JORDAN VALLEY WATER TREATMENT PLANT
FILTER AND CHEMICAL FEED UPGRADES

JVWCD PROJECT #4289

ADDENDUM NO. 4
TO THE
CONTRACT DOCUMENTS

MAY 2025

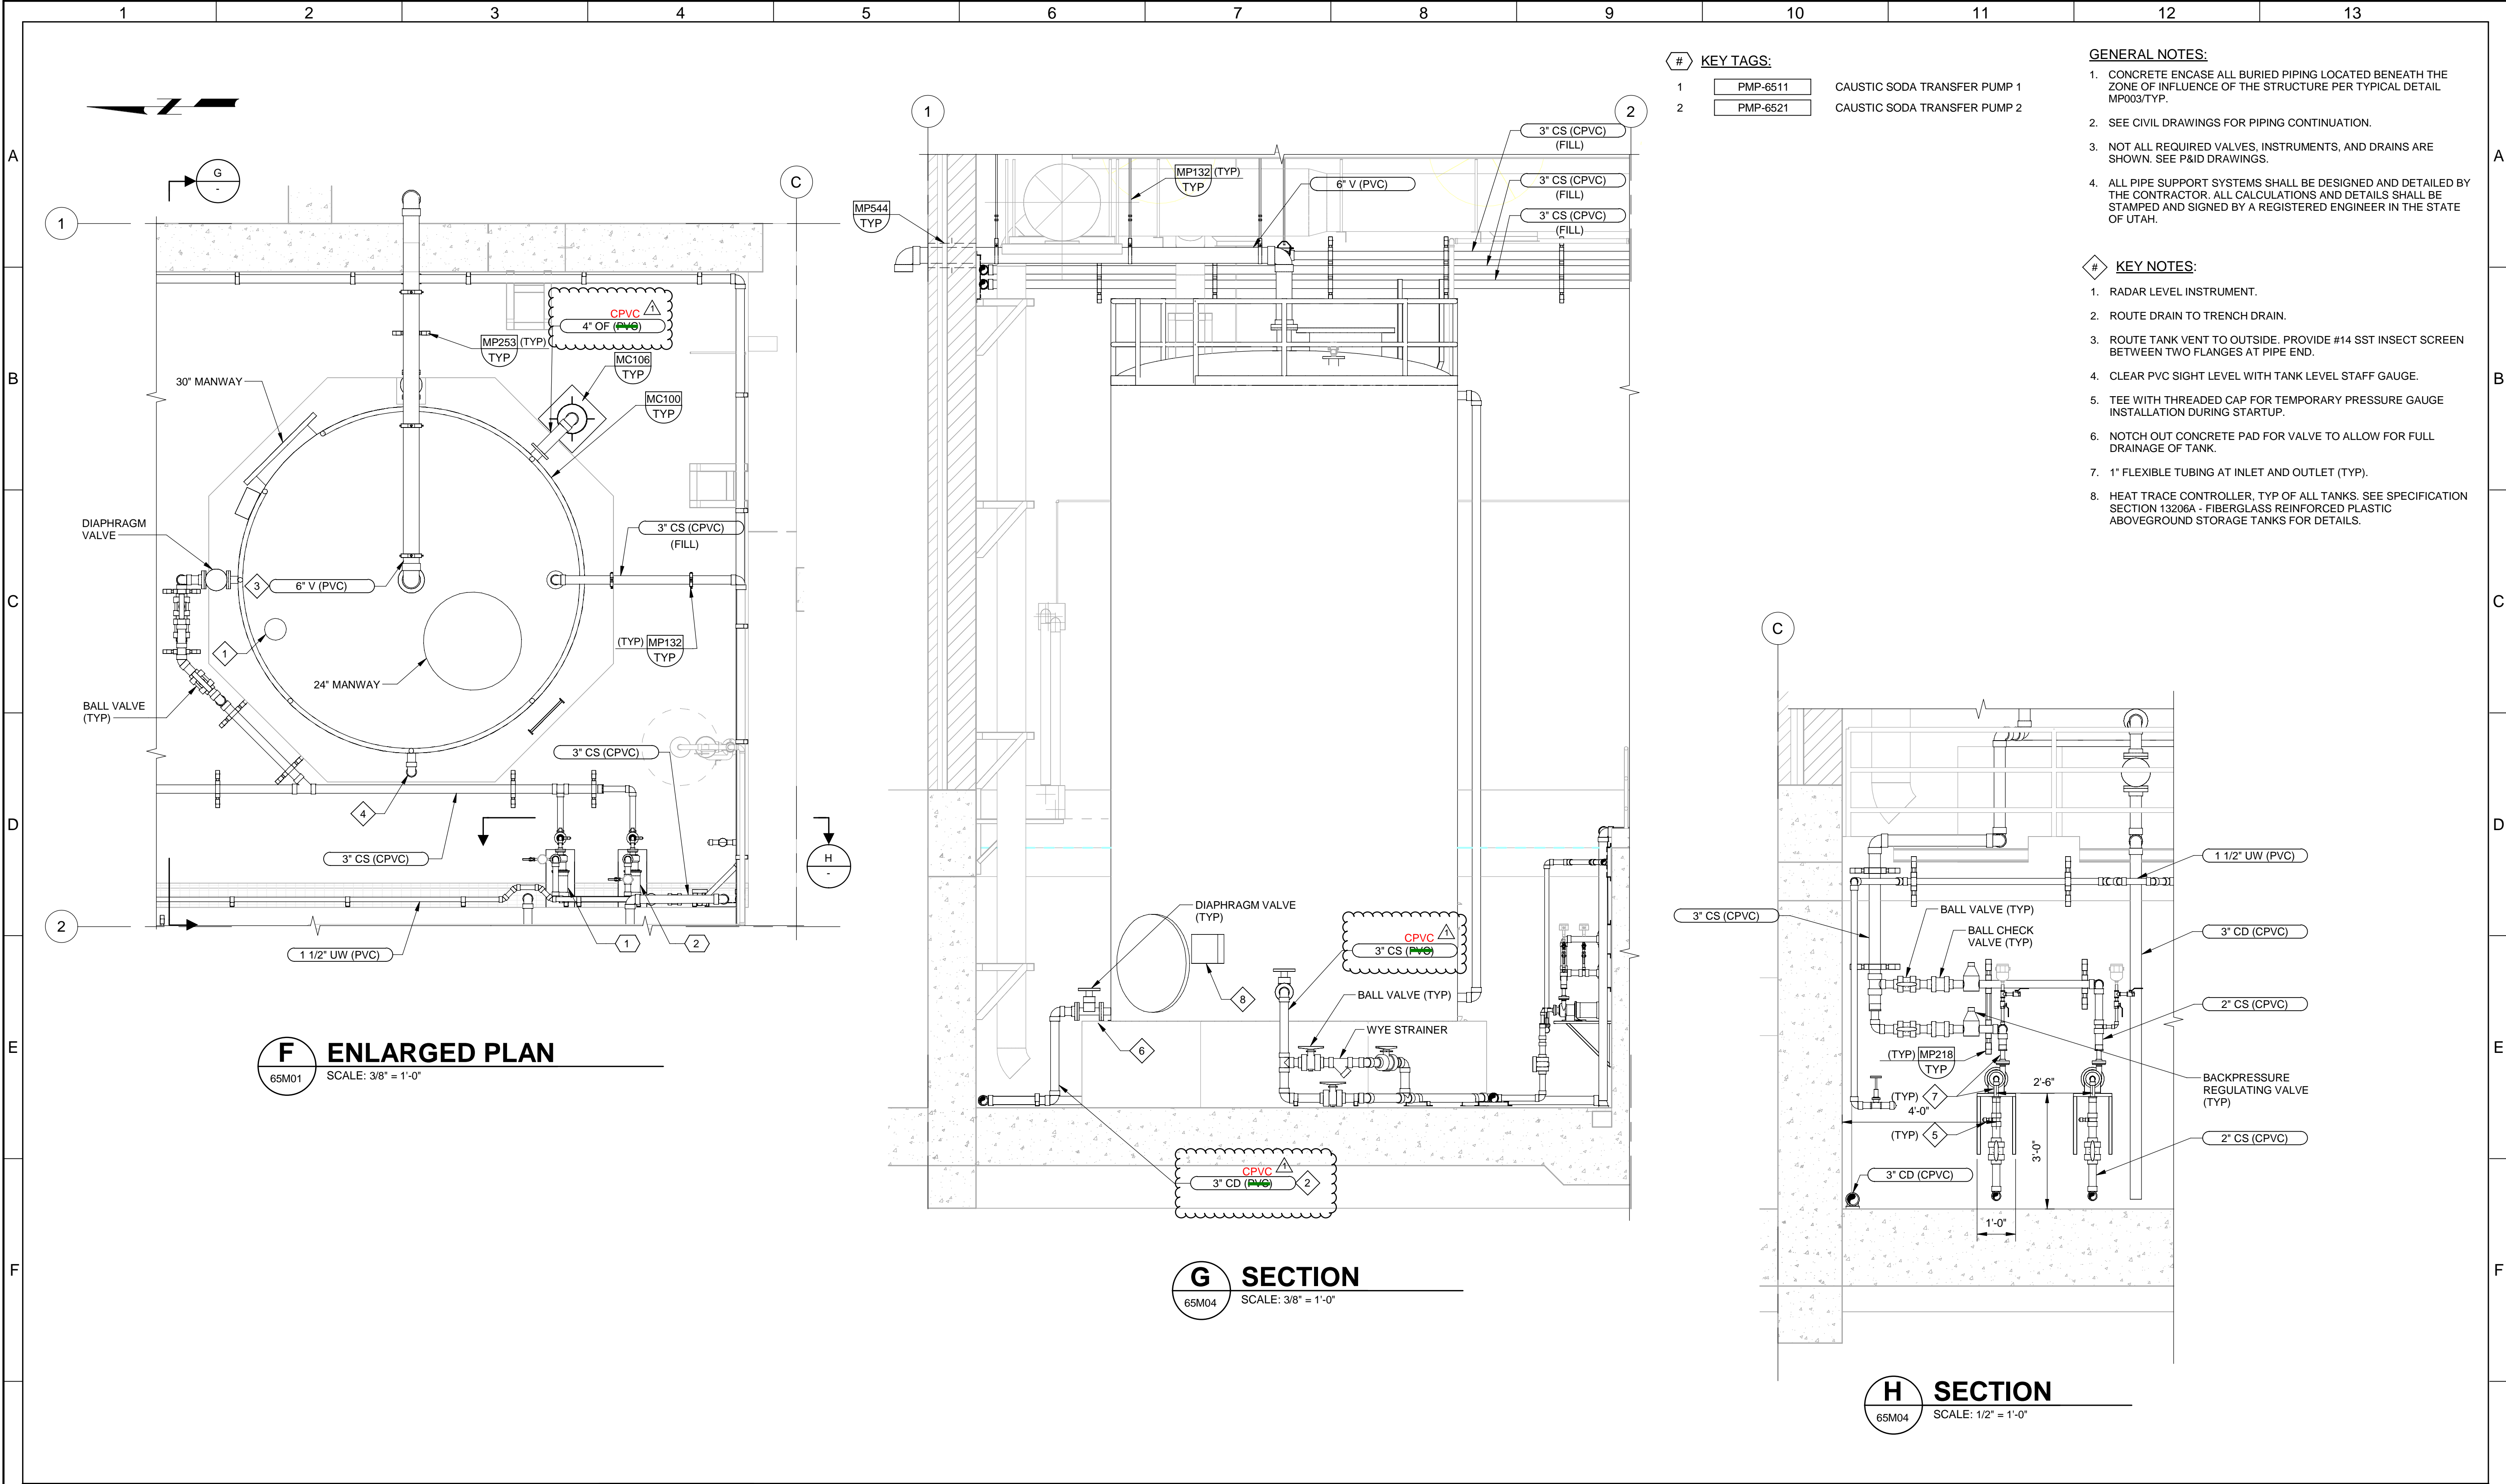
26	On Drawing 65M04 Sections G & H the 3" CD line is shown as PVC in one section and CPVC in the other. Please clarify.	The CD lines should all be CPVC in the Caustic Soda Building. This has been updated in Addendum 4.
27	On Drawing 65M04 detail F the vapor seal and overflow piping are called out as PVC, please confirm material types for these chemicals are suitable for PVC.	Vapor seal shall be PVC per detail MC106, but overflow piping in the Caustic Soda Building should be CPVC. This has been updated in Addendum 4.
28	On Drawing 69M03 do the vent and fill lines from the PES tanks need to transition to steel outside the building?	No, they should remain PVC. However, they should be painted to protect from sunlight exposure. This has been updated in Addendum 4.

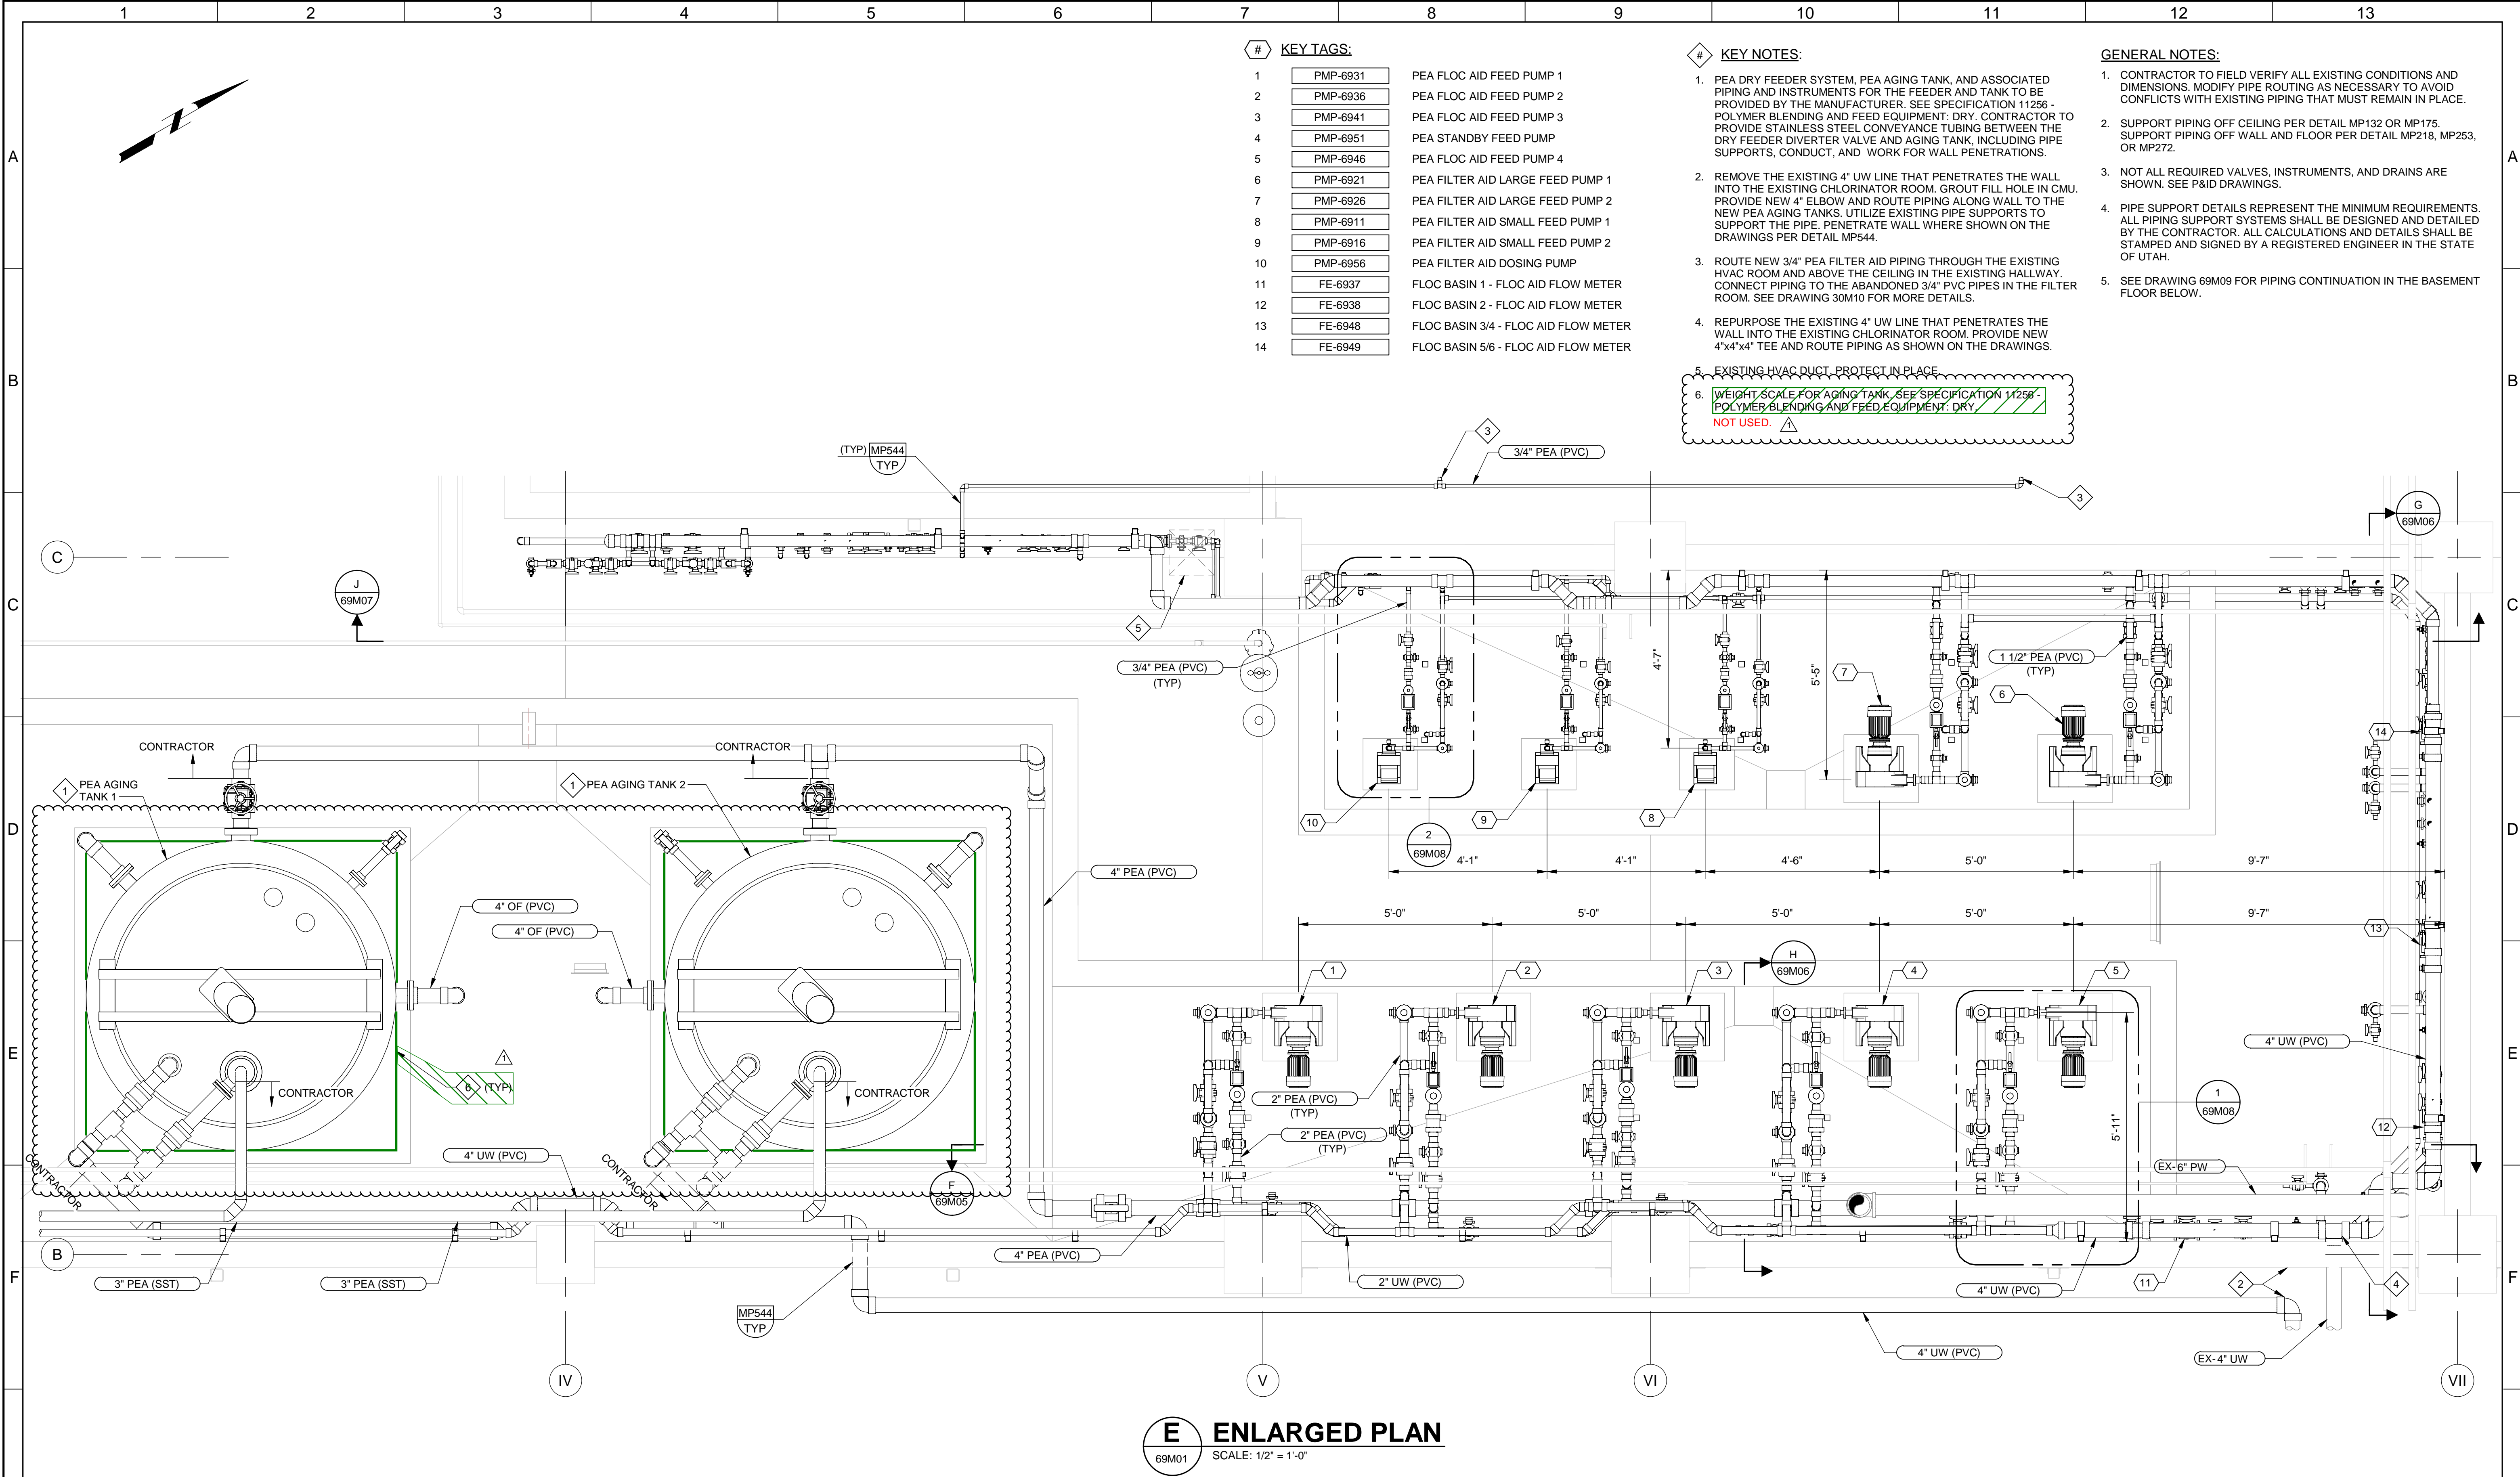
- 5 - EXISTING HVAC DUCT, PROTECT IN PLACE
- 6 - WEIGHT SCALE FOR AGING TANK, SEE SPECIFICATION 11256 - POLYMER BLENDING AND FEED EQUIPMENT: DRY. NOT USED.

EM021 DUCT BANK CROSSING UNDER FOOTER
TYP

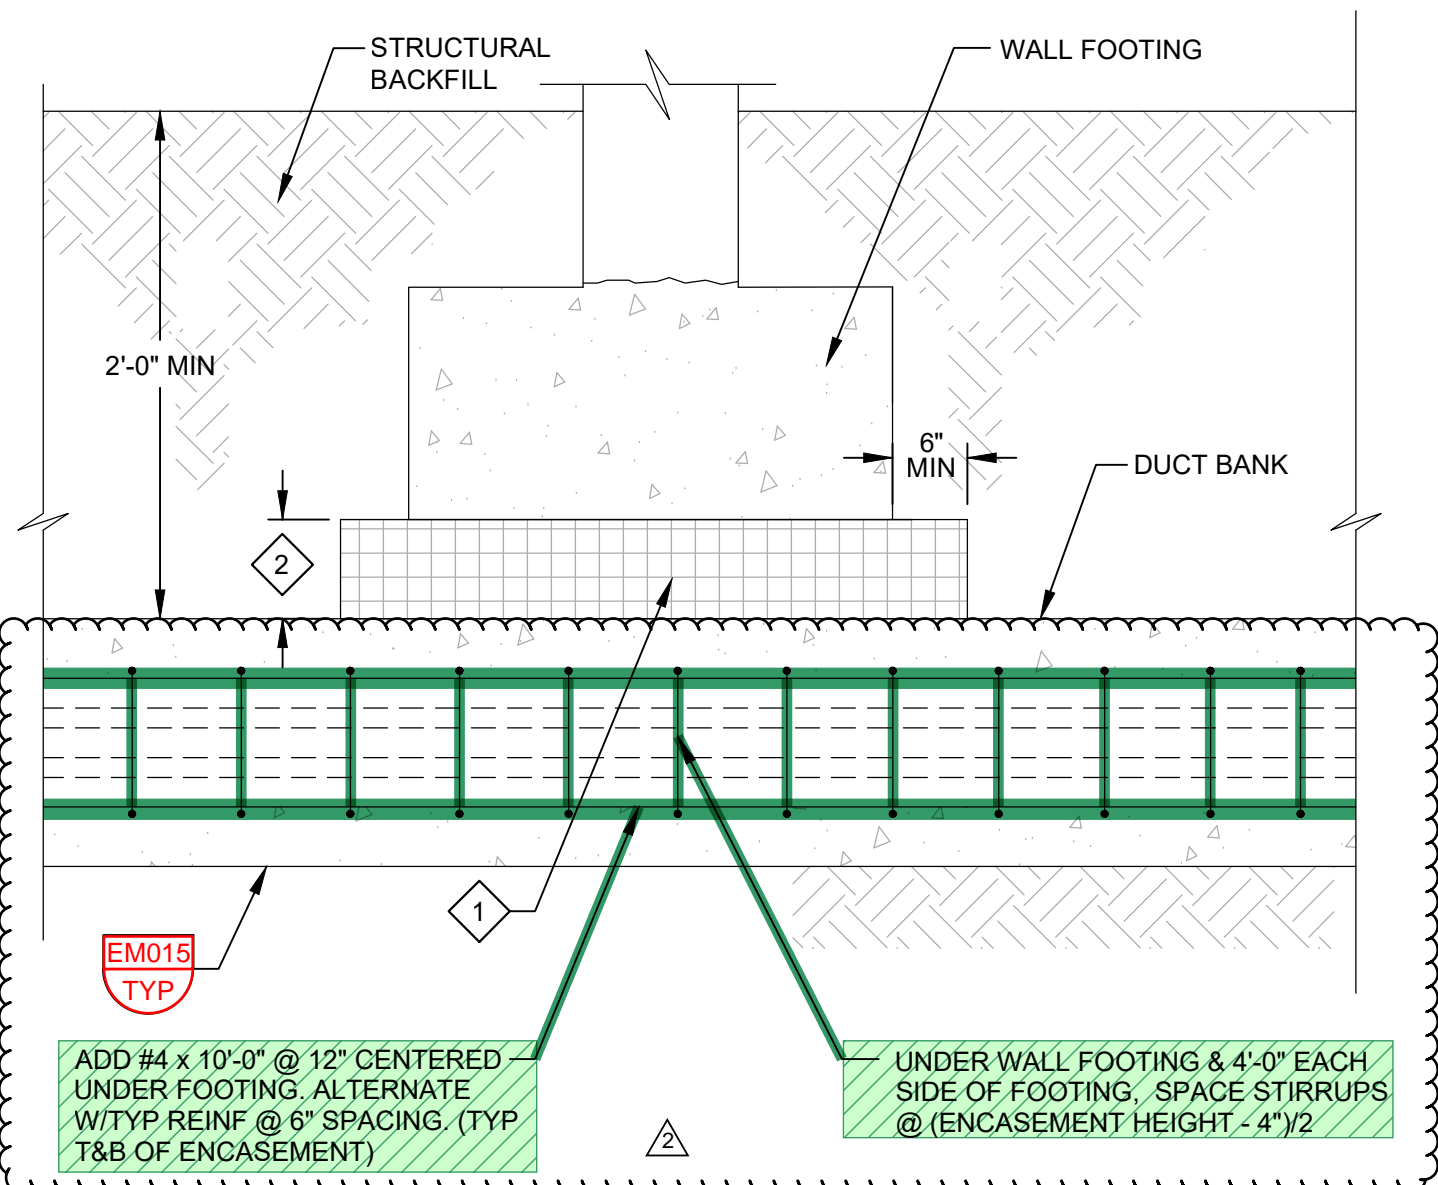
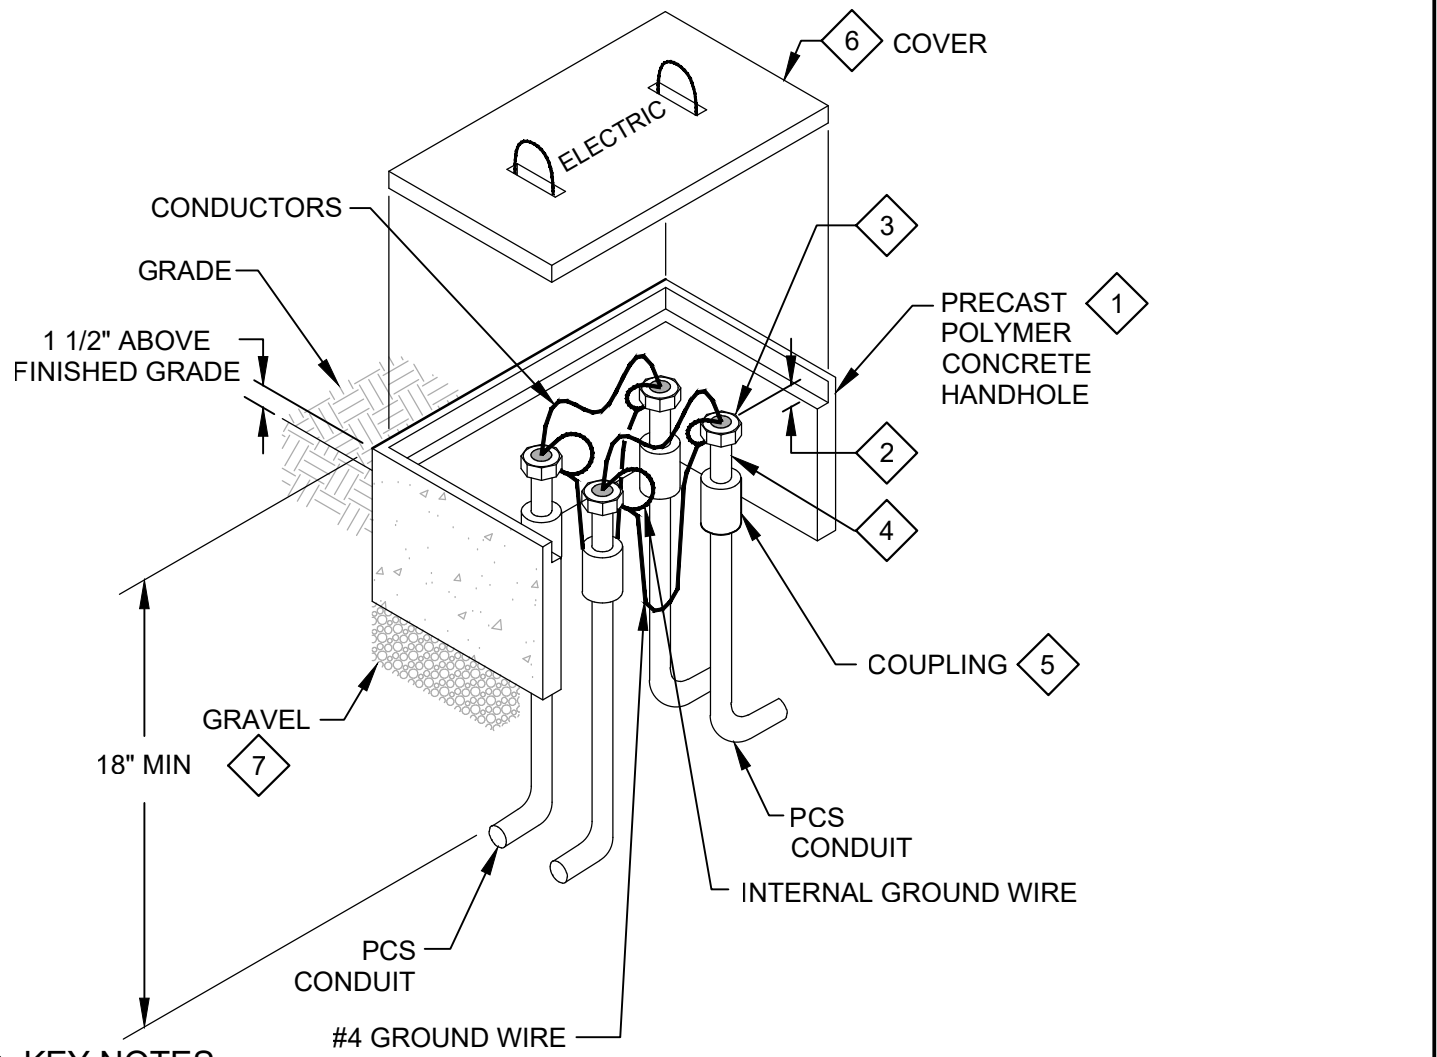
14	Typical Detail EM021 refers to Typical Detail EM001. This detail has not been provided. Please provide detail EM001.	Typical Detail EM021 should refer to EM015. This has been addressed by markup.
15	Tag # C-62-235 runs between the Primary Coagulant Building and the Chlorine Dioxide Building on sheet 01E03 but has not been included with the Conduit schedule. Please clarify the conduit size, conductors, and connections for this run.	Conduit C-62-235 on drawing 01E03 should be C-62-325.
16	There is some conflict in the drawings regarding the electrical disconnects for HVAC equipment. There are notes in the electrical drawings that state to connect power to the integral disconnect at the HVAC equipment, but the equipment schedules in the HVAC drawings state that the electrical contractor is to provide the disconnect. EF-6357 & SF-6368 (00GH02 & 63E11) are some examples. Please clarify whose scope the disconnects fall under to avoid scope gaps or double coverage.	HVAC manufacturer to provide electrical disconnects for HVAC equipment.
